**FILE** P.I. #0007421  
CSNHS-0007-00(421)  
GDOT District 5 - Jesup  
McIntosh County  
I-95 @ SR 251/Briardam Road

**SUBJECT** **APPROVED REVISED CONCEPT REPORT**

**REVISED PROJECT CONCEPT REPORT**

Project Number: CSNHS-0007-00(421)

THE LPA GROUP TRANSPORTATION CONSULTANTS NORTWICH, GEORGIA 30062 (770) 283-9116	REVISOR DATES	STATE OF GEORGIA DEPARTMENT OF TRANSPORTATION
	<b>TYPICAL SECTION</b>

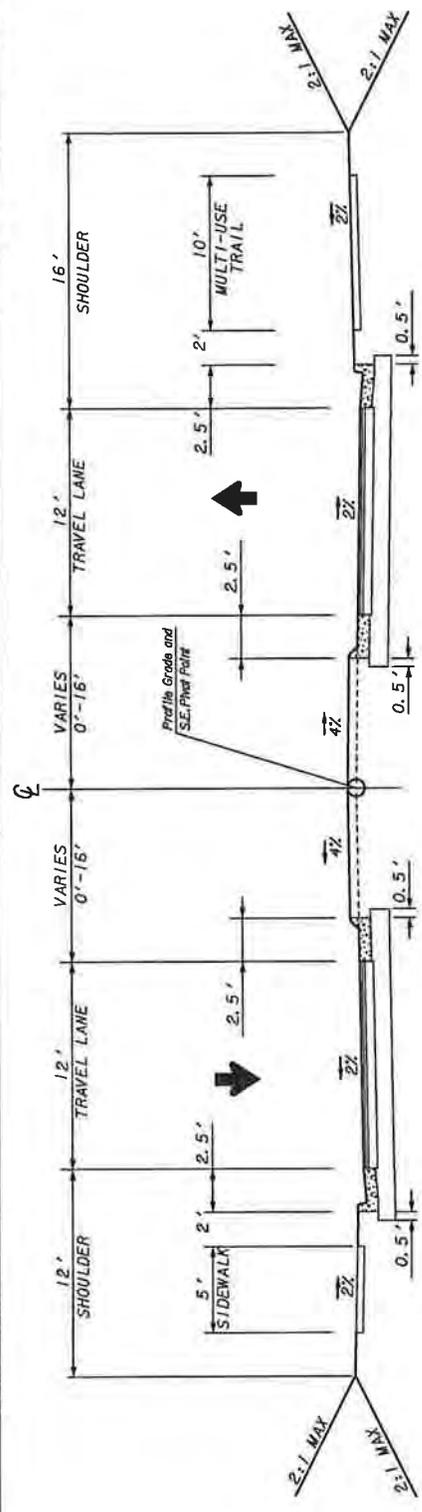
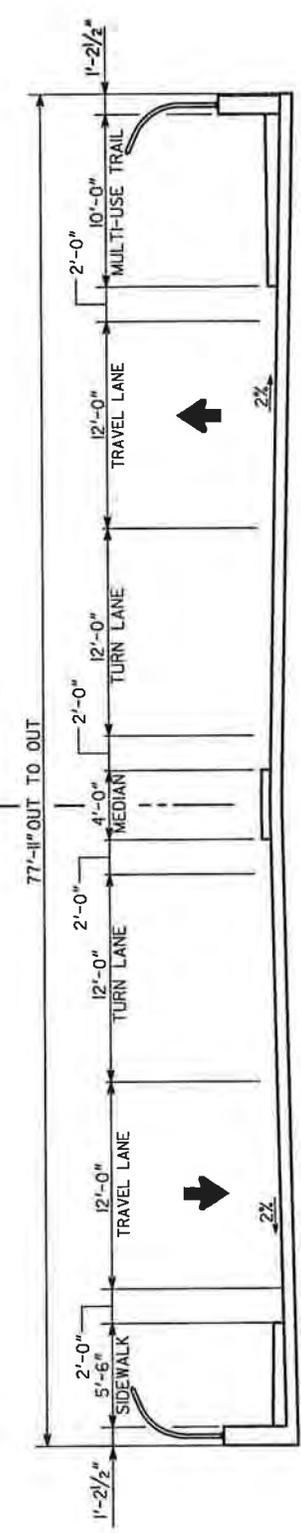
<p><b>Approved Features:</b></p> <ul style="list-style-type: none"><li>• <i>Typical section</i></li></ul> <p>Construct a 4-lane divided urban section, including 4-foot bike lanes, 16-foot urban shoulder with 5-foot sidewalk on both sides along S.R. 251. The existing 2-lane bridge over I-95 was to be replaced with a new six lane bridge which included two left turn lanes. The new bridge on S.R. 251 would achieve the required vertical and horizontal clearance for the widening of I-95.</p> <ul style="list-style-type: none"><li>• <i>Access Control</i></li></ul> <p>Design Variance not anticipated for access control.</p>	<p><b>Proposed Features:</b></p> <ul style="list-style-type: none"><li>• <i>Typical section</i></li></ul> <p>Construct a 2-lane urban section including turn lanes where necessary, including a 16-foot urban shoulder with a 10-foot multi-use path on the south side and a 12-foot urban shoulder with a 5-foot sidewalk on the north side. The existing 2-lane bridge over I-95 will be replaced with a new 4-lane bridge which included two left turn lanes. The new bridge on S.R. 251 would achieve the required vertical and horizontal clearance for the widening of I-95.</p> <ul style="list-style-type: none"><li>• <i>Access Control</i></li></ul> <p>A Design Variance will be needed for the minimum 300 foot distance from the southbound exit ramp to the nearest driveway, from the northbound exit ramp to the nearest driveway, and from the northbound entrance ramp to the nearest driveway.</p>

<p><b>Reason for Change:</b> The typical section has been revised based on traffic capacity requirements, logical termini requirements, and the VE Study Recommendations. A Design Variance is recommended for the minimum 300 foot distance needed for control of access from the interstate ramps to driveways serving existing commercial property.</p>

Project CSNHS-0007-00(421) will consist of a 2-lane urban section including turn lanes where necessary, including a 16-foot urban shoulder with a 10-foot multi-use path on the south side and a 12-foot urban shoulder with a 5-foot sidewalk on the north side. The existing 2-lane bridge over I-95 will be replaced with a new 4-lane bridge which includes two left turn lanes. The new bridge on S.R. 251 would achieve the required vertical and horizontal clearance for the widening of I-95. The typical section has been revised based on traffic capacity requirements, logical termini requirements, and also to implement the VE Study's recommendation letter dated May 15, 2008:
